## **Boggabri Coal Mine Modification 8 Amendment**

### **Updated Surface Water Assessment**

17 November 2022

Appendix A: Response to Comments

### Figure 3-1: Proposed Conceptual WMS - 2023

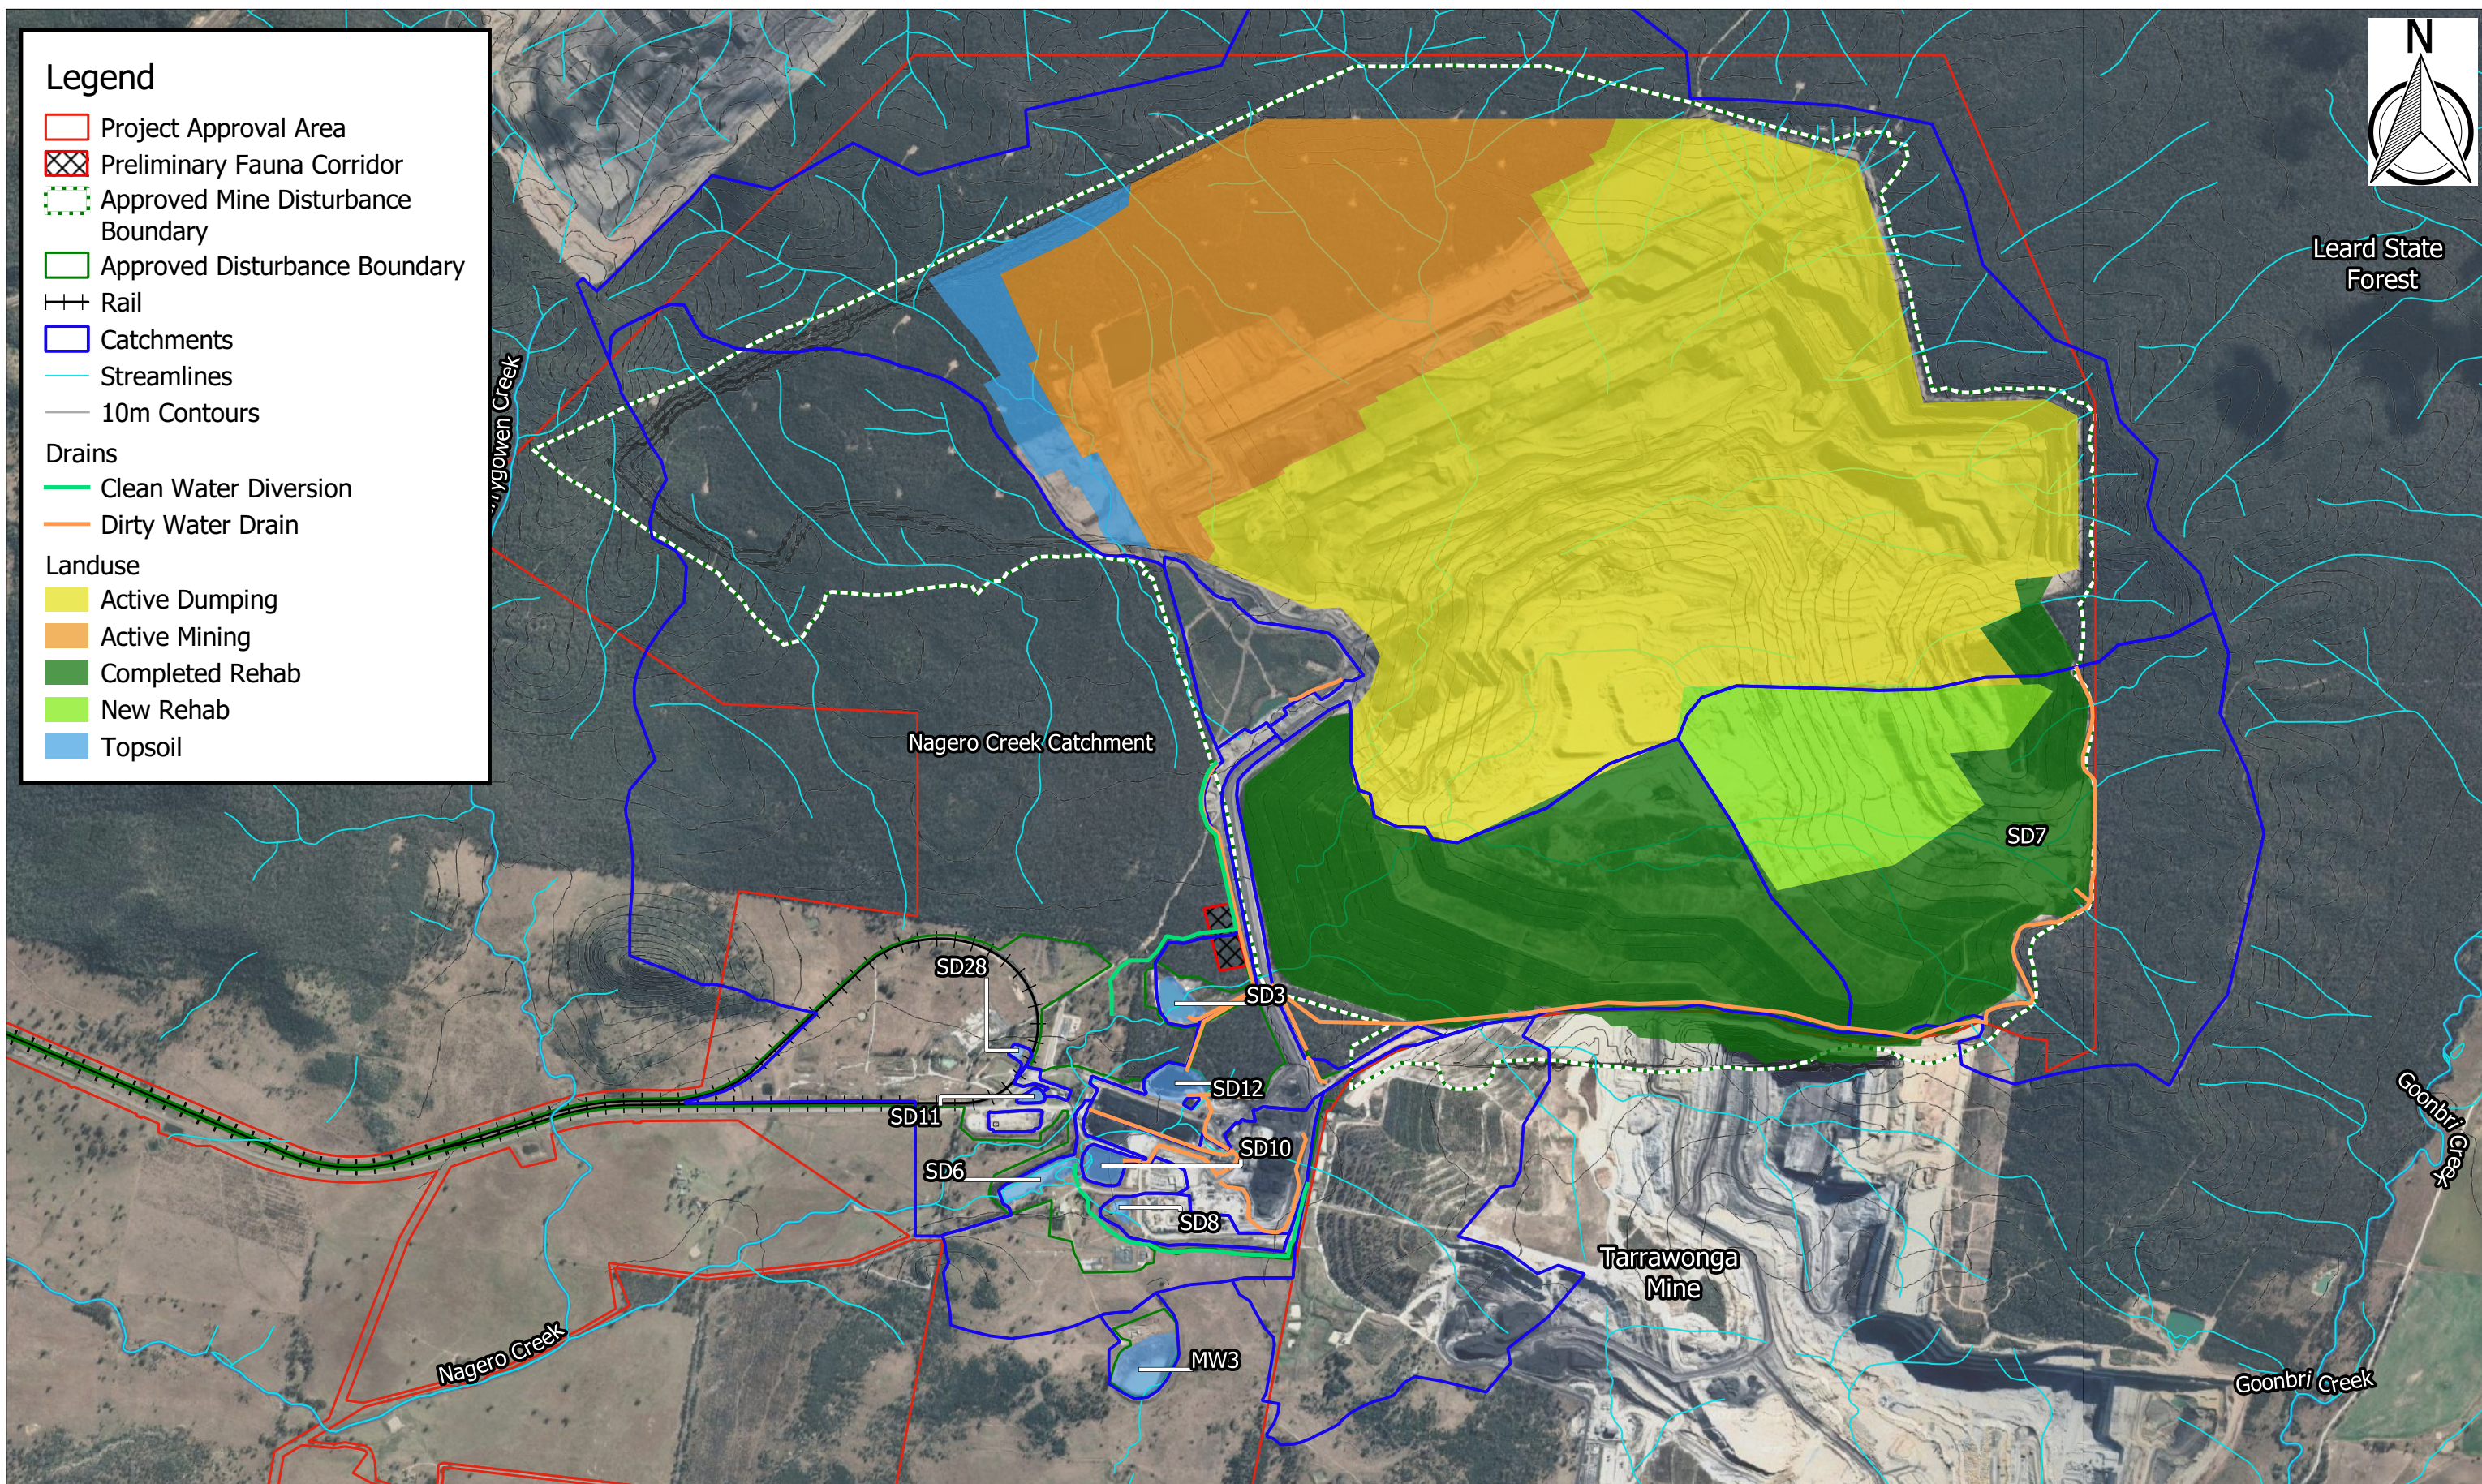
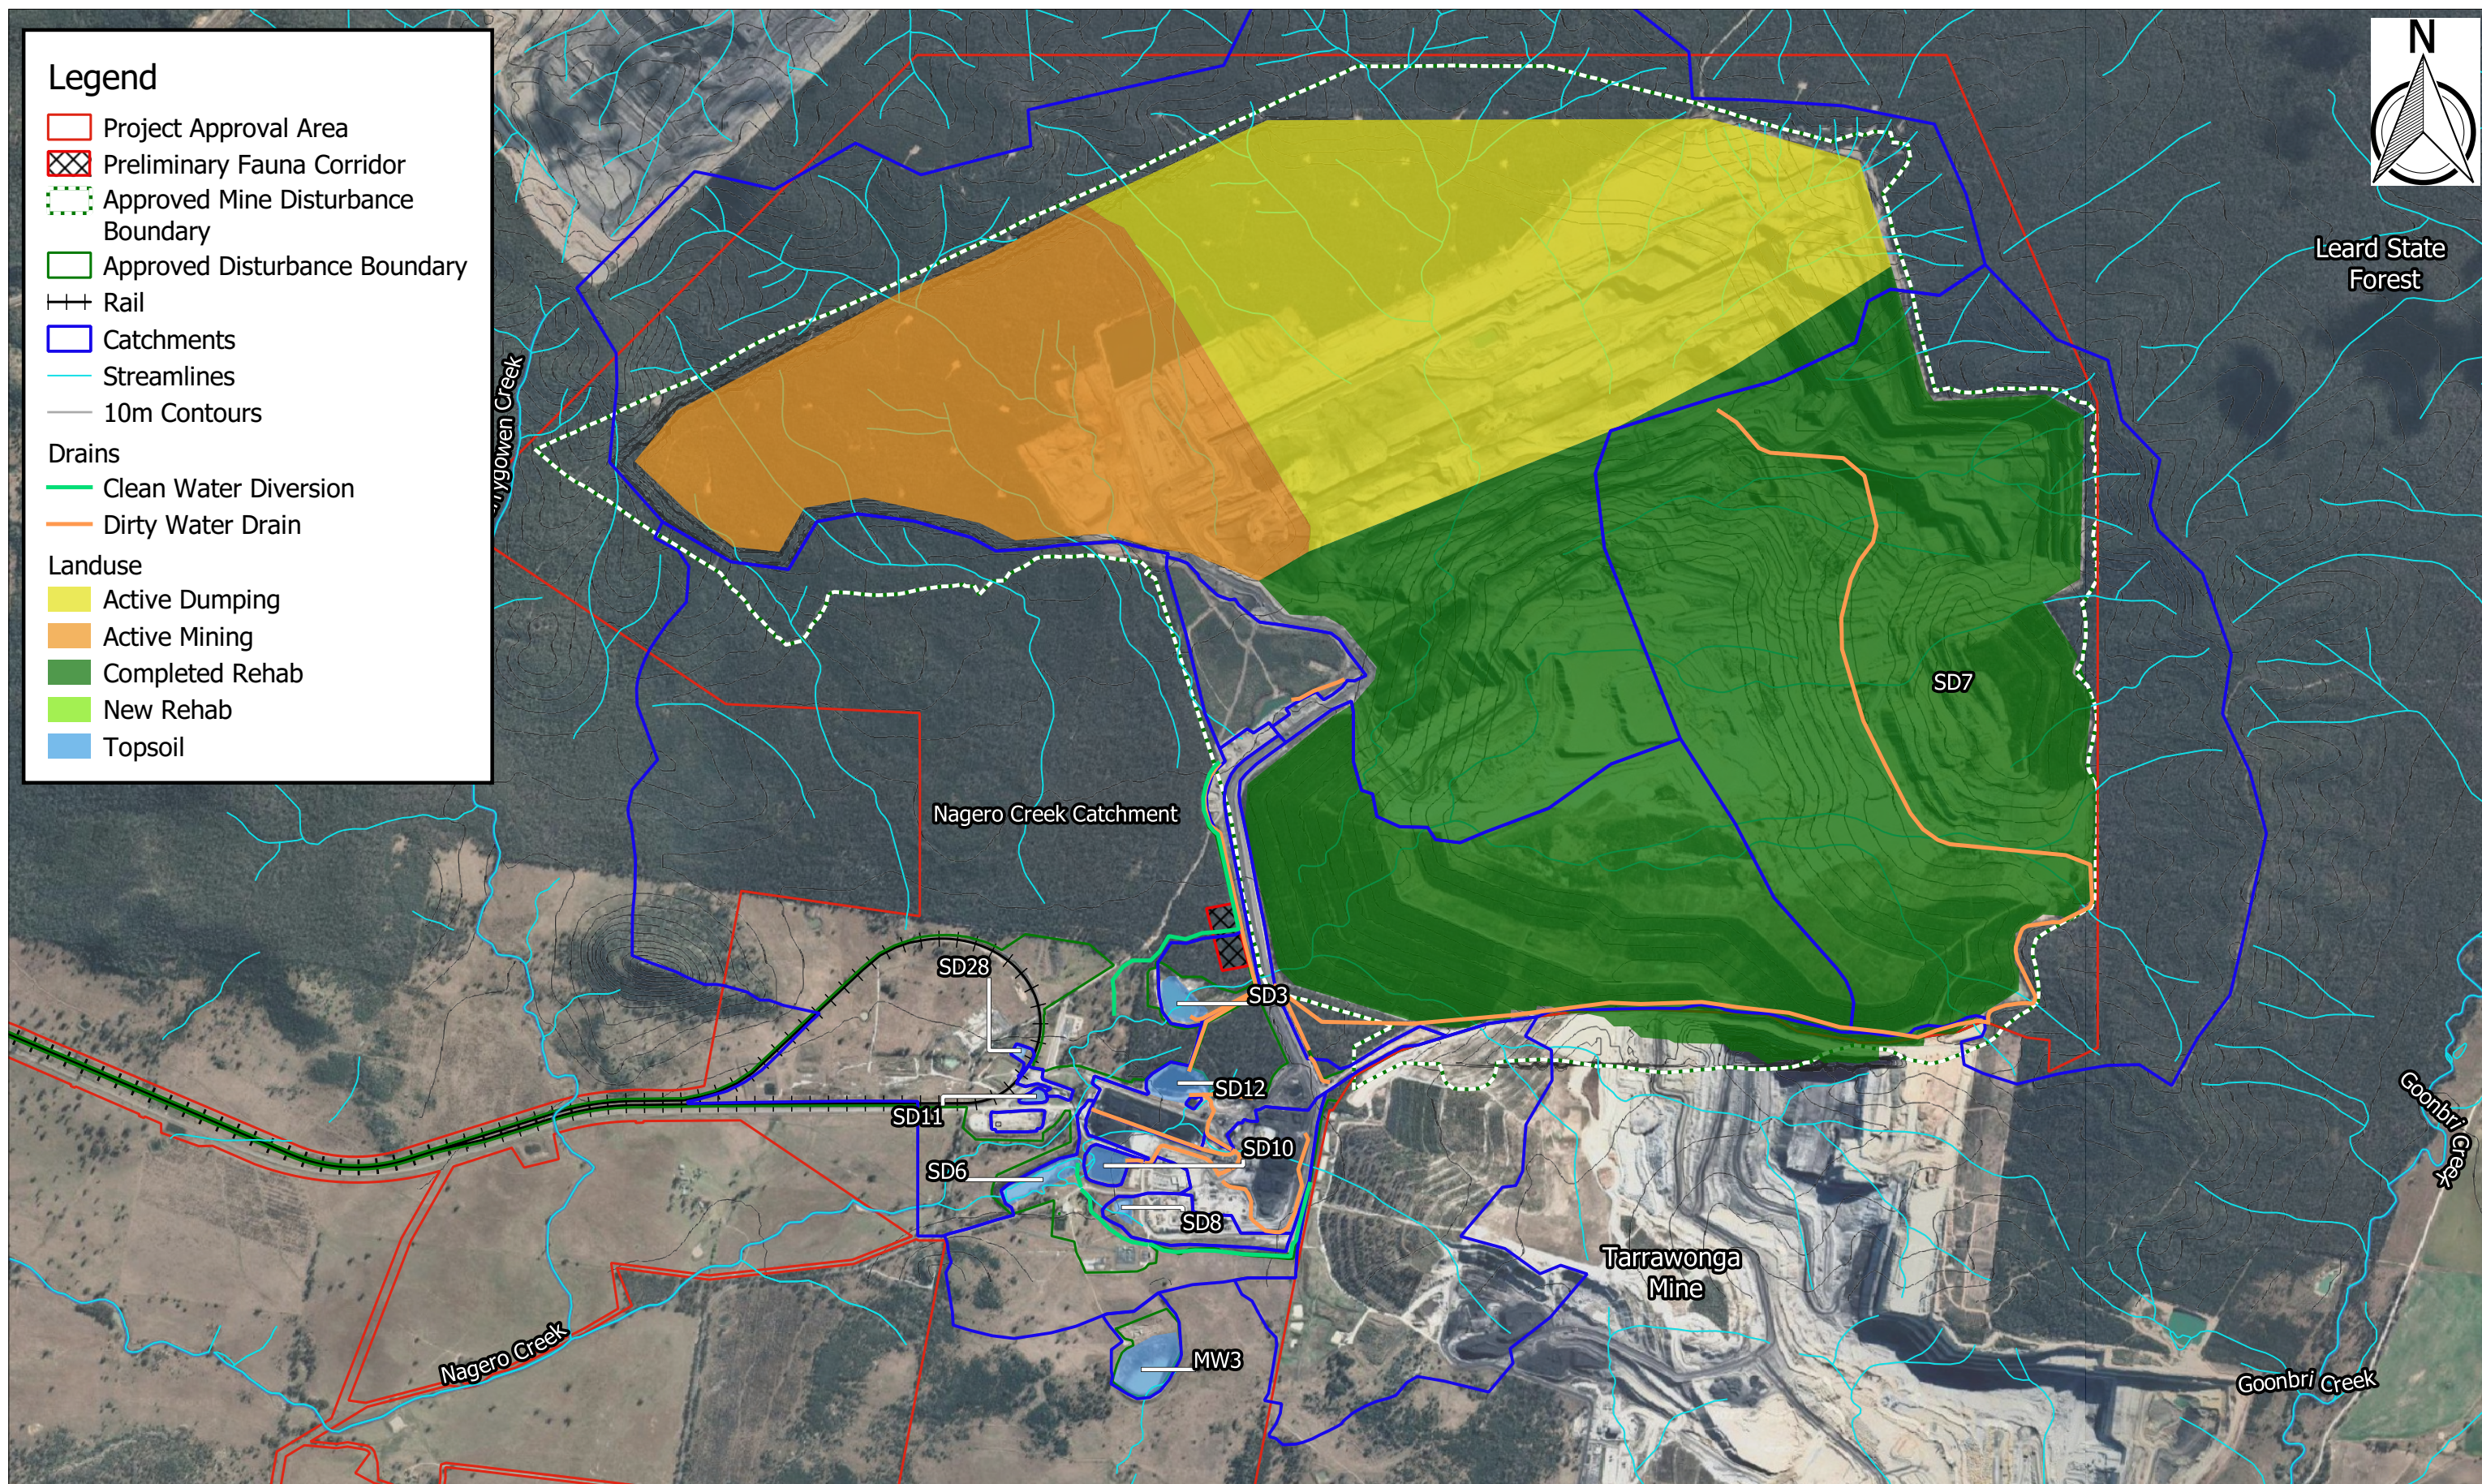
| Comment                                                                                                                                                                                                                                                                                                                                                                                                                                                                                                                                                                                                                                                                                         | Response                                                                                                                                                                                                                                                                                                   |
|-------------------------------------------------------------------------------------------------------------------------------------------------------------------------------------------------------------------------------------------------------------------------------------------------------------------------------------------------------------------------------------------------------------------------------------------------------------------------------------------------------------------------------------------------------------------------------------------------------------------------------------------------------------------------------------------------|------------------------------------------------------------------------------------------------------------------------------------------------------------------------------------------------------------------------------------------------------------------------------------------------------------|
| <p>i. The Figures 3.1-3.5 (Engeny 2021) show the clean runoff water is captured following drainage along a roadside through the coal rail line. Further information and details on how the clean water which passes this area is not contaminated by coal dust and other contaminants from runoff during wet weather events should be provided. Monitoring of the water quality may be required to provide assurances the water is not contaminated.</p>                                                                                                                                                                                                                                        | <p>Alternate flow path defined to match existing watercourse. Refer to Figures 3.1 to 3.4</p>                                                                                                                                                                                                              |
| <p>iii. The clean water diversion point south of the rail line appears to drain into a paddock. The proponent should provide information on this site in a sediment and erosion management plan, which provides assurances there is no runoff or erosion occurring during rainfall events.</p>                                                                                                                                                                                                                                                                                                                                                                                                  | <p>Alternate flow path defined to match existing watercourse. Does not discharge into paddock. Refer to Figures 3.1 to 3.4.</p>                                                                                                                                                                            |
